ADDENDUM NO. 2
to the
PROJECT DOCUMENTS AND SPECIFICATIONS
for
T-HANGAR DEVELOPMENT

AVCON Project No. 2022.0241.01

Addendum Date: November 7, 2024

ADDENDUM NO. 2
T-HANGAR DEVELOPMENT
Calhoun County Airport

TYPICAL FENCE DETAILS
RELEASE FOR BID

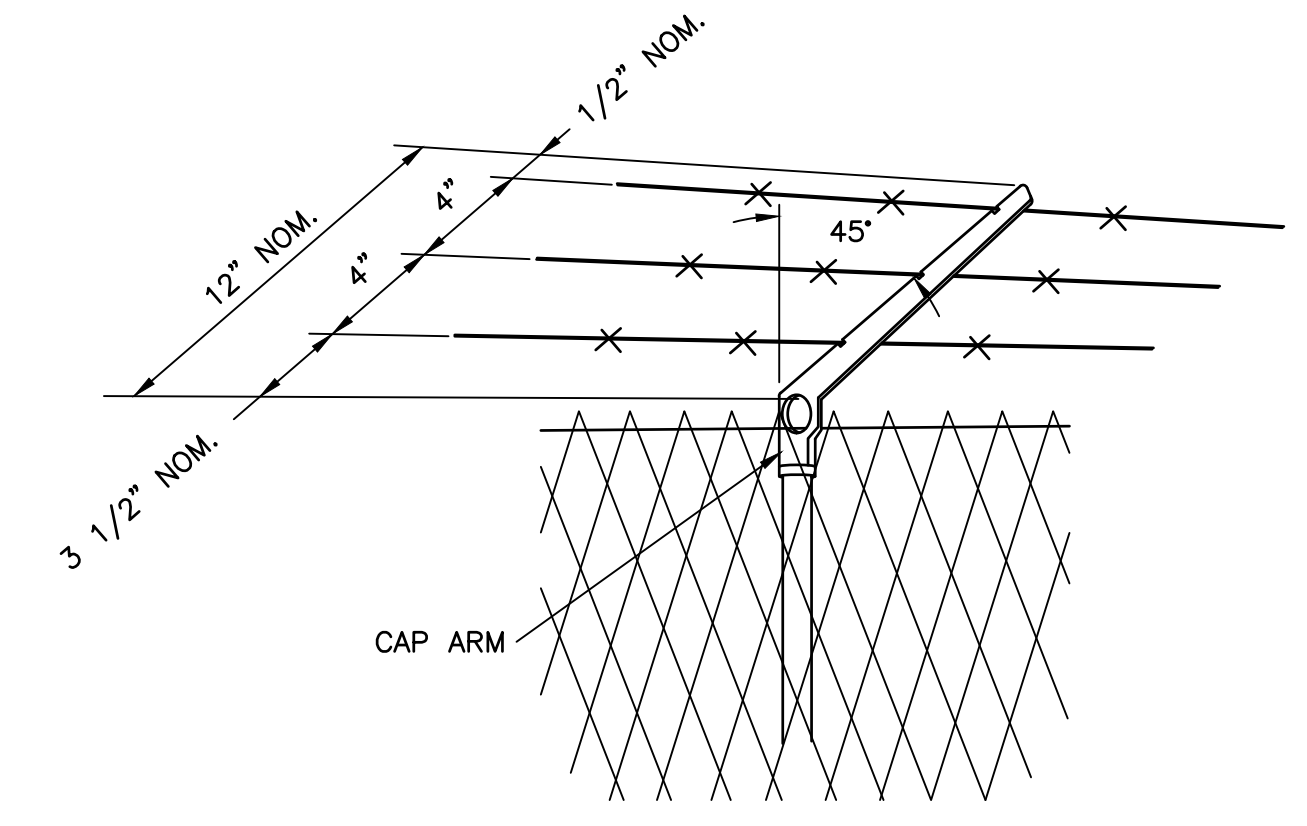
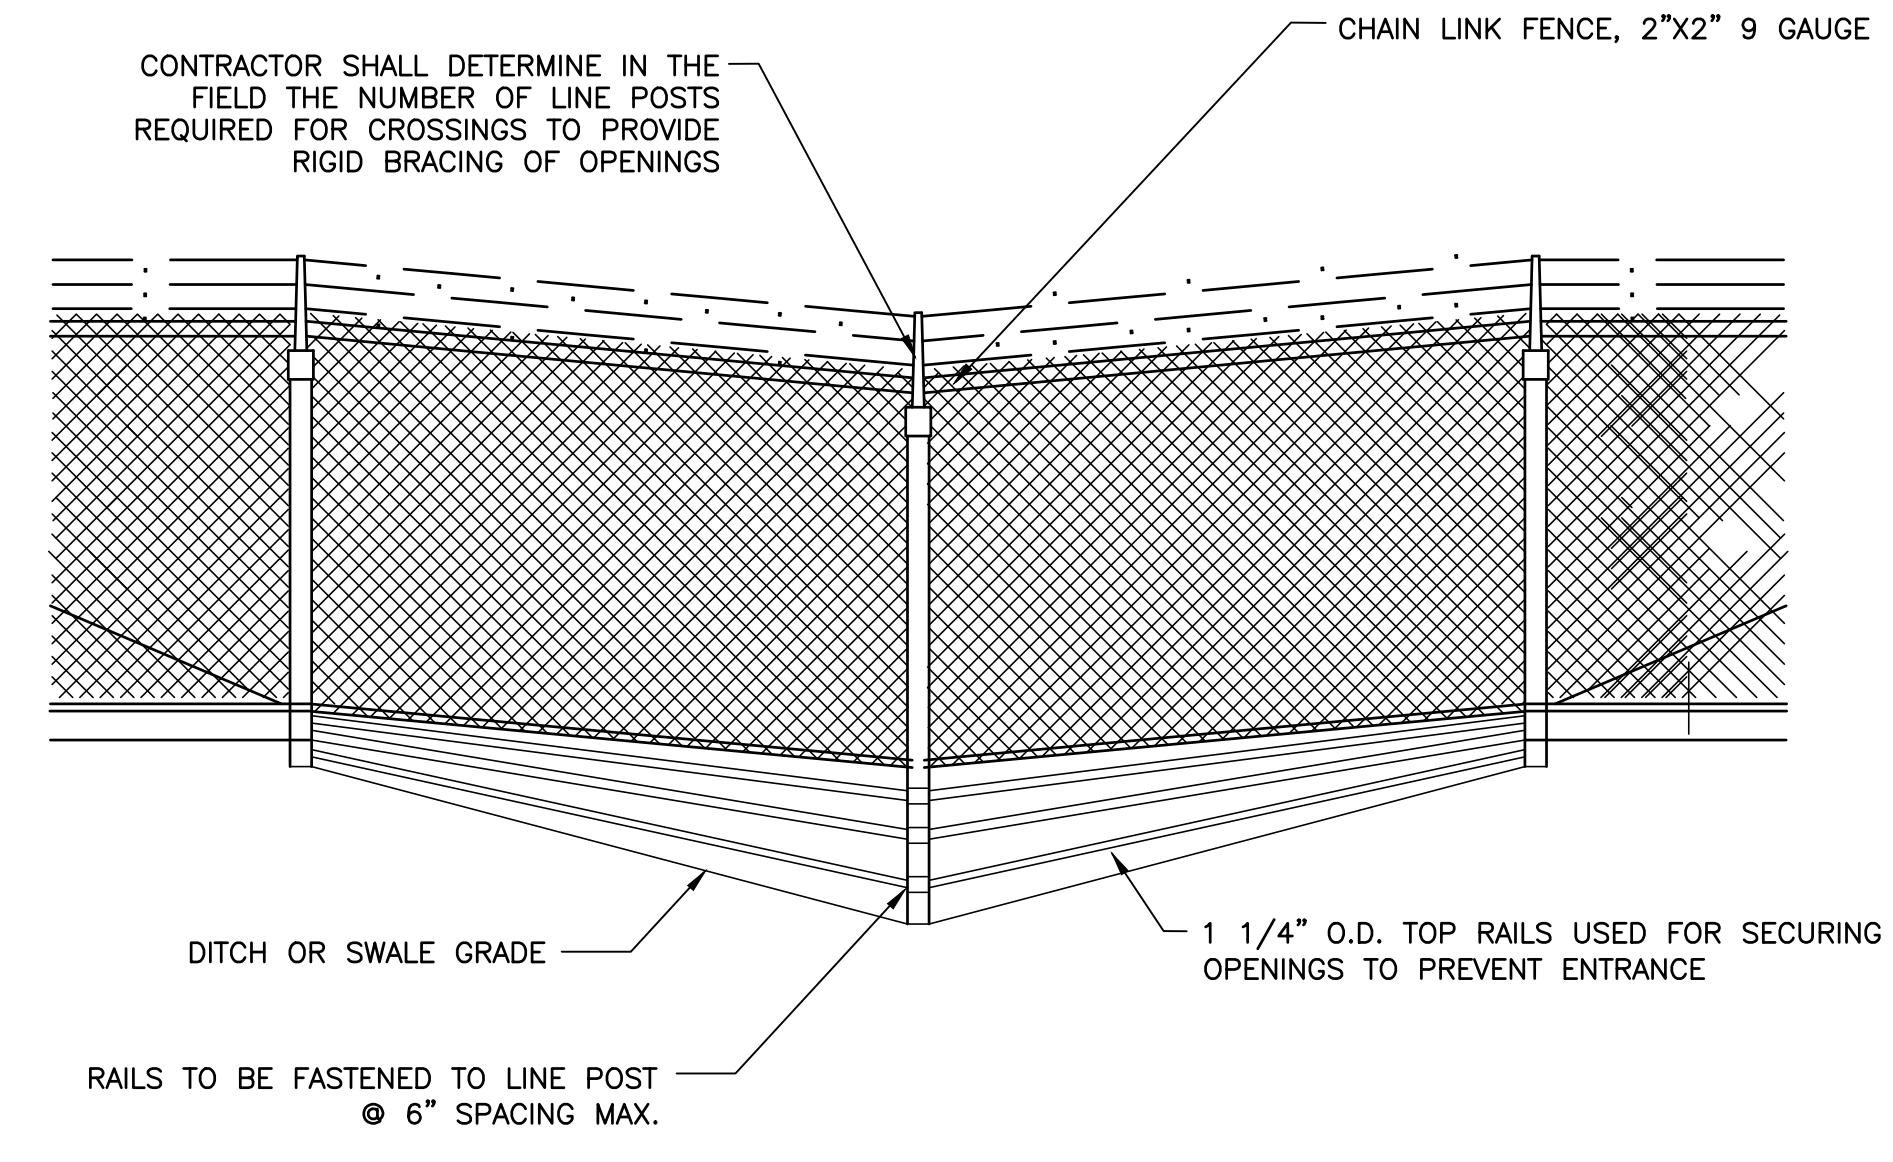
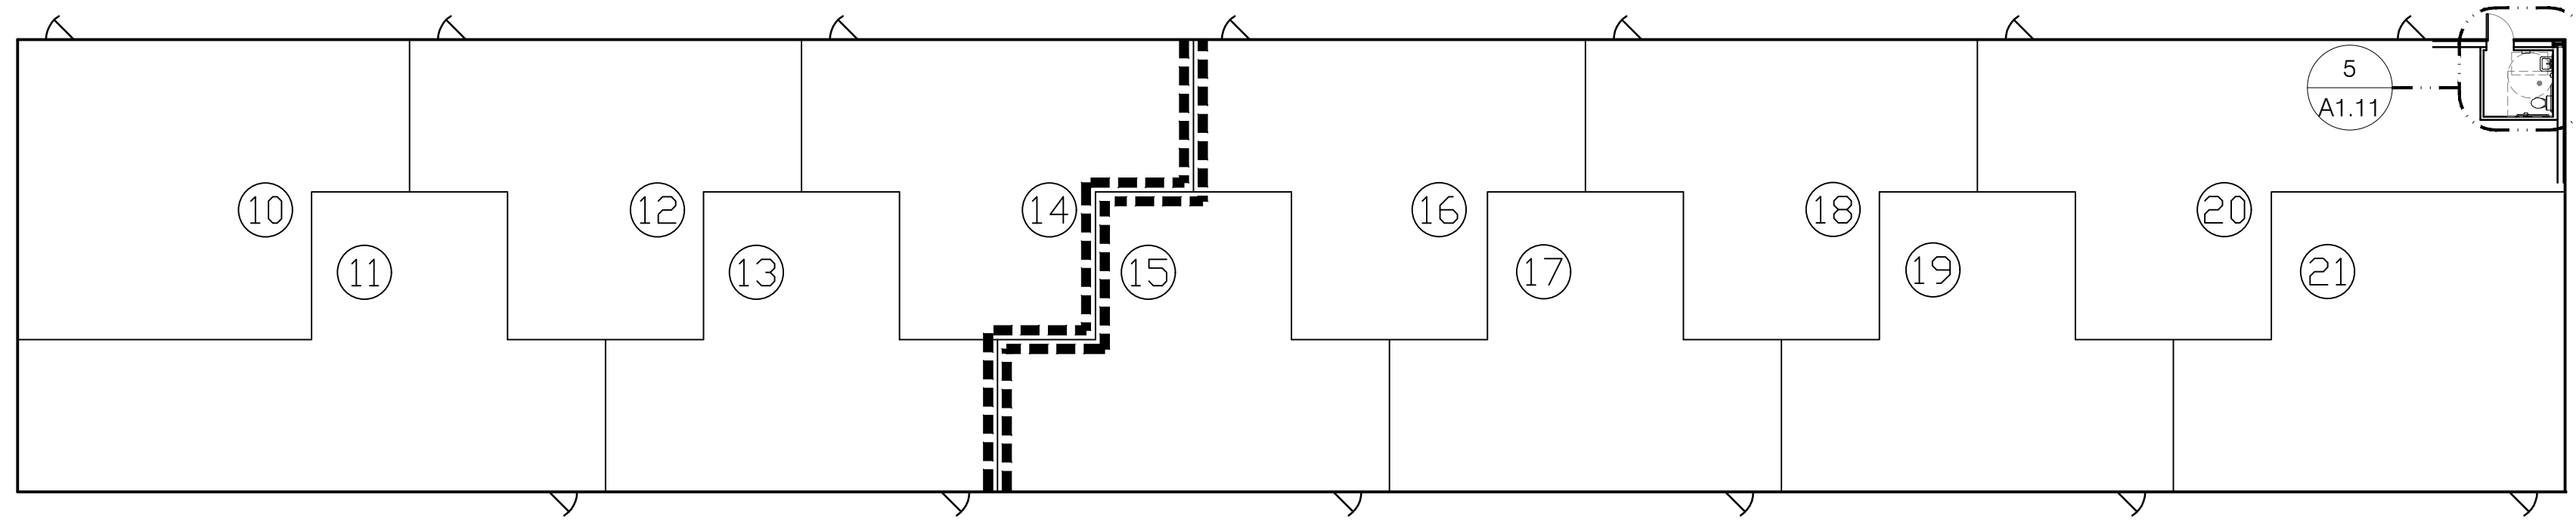
9. Fencing: What is the detail for the fencing, i.e. how big are the posts (line, terminal, and gate) what material do they require?

RESPONSE: In accordance with Technical Specification F-162, Chain-Link Fences, the post sizes shall be in accordance with Federal Specification RR-F-191/3. The line posts, rails, and braces shall be galvanized steel pipe conforming to the requirements of ASTM F 1083.
